UNITED STATES PATENT AND TRADEMARK OFFICE

APPLICATION NO.	FILING DATE	FIRST NAMED INVENTOR	ATTORNEY DOCKET NO.	CONFIRMATION NO.
09/541,765	04/03/2000	Mareike Klee	PHD 99.046	4722

Office Action Summary

DETAILED ACTION

FIG. 1

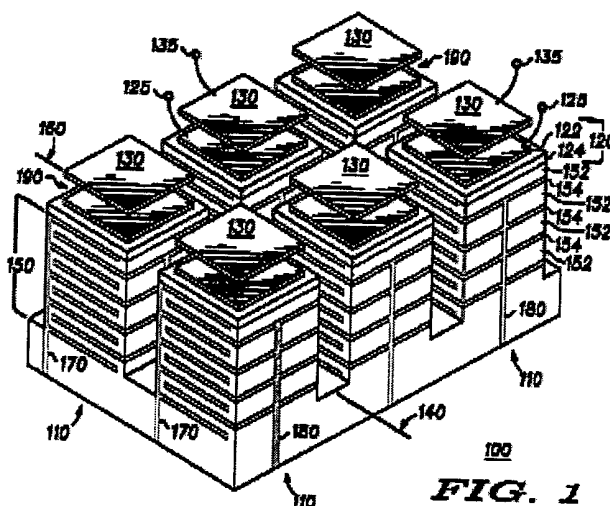
Regarding claims 1, & 10, Malone et al. disclose in fig. 1, a ceramic passive component (100) comprising a carrier substrate (col. 9 lines 40-45, col. 1 lines 35-37); one first electrode (154) formed of a metal and having a first surface disposed on the substrate, a dielectric (152) having a first surface disposed, on a second surface of the

first electrode opposing the first surface of the first electrode and a second electrode (154, 122 & col. 2 lines 39-48), disposed on a second surface of the dielectric opposing the first surface of the dielectric, wherein the dielectric is a ferroelectric ceramic with a voltage-dependent relative dielectric constant (see abstract materials). (Regarding claim 10, the ceramic passive component can be used in a filter (col. 1 lines 30-40)).

Regarding claim 2, Malone et al. disclose the ferroelectric ceramic material with a voltage-dependent dielectric constant is a $\text{Pb}(\text{Zr}_x\text{Ti}_{1-x})\text{O}_3$ wherein x varies from 0 to 1 (abstract).

Regarding claim 3, Malone et al. disclose the second electrode (152, 122 & col. 2 lines 39-48) discloses first (152) and second (122 (without 124 –see col. 2 lines 39-48)).

Regarding claim 5, Malone et al. disclose the second electrically conducting layer (122) comprises a metal.

Regarding claim 12, Malone et al. disclose a use of a ceramic passive component (100) which comprises: a carrier substrate, a first electrode (154) comprising a metal having a first surface disposed on a substrate, a dielectric layer (152) having a first surface disposed on a second surface of the first electrode, a second electrode (154) disposed on a second surface of the dielectric layer, and said dielectric comprises a ferroelectric ceramic material with a voltage dependent relative dielectric constant (see abstract & col. 3 lines 28-36).
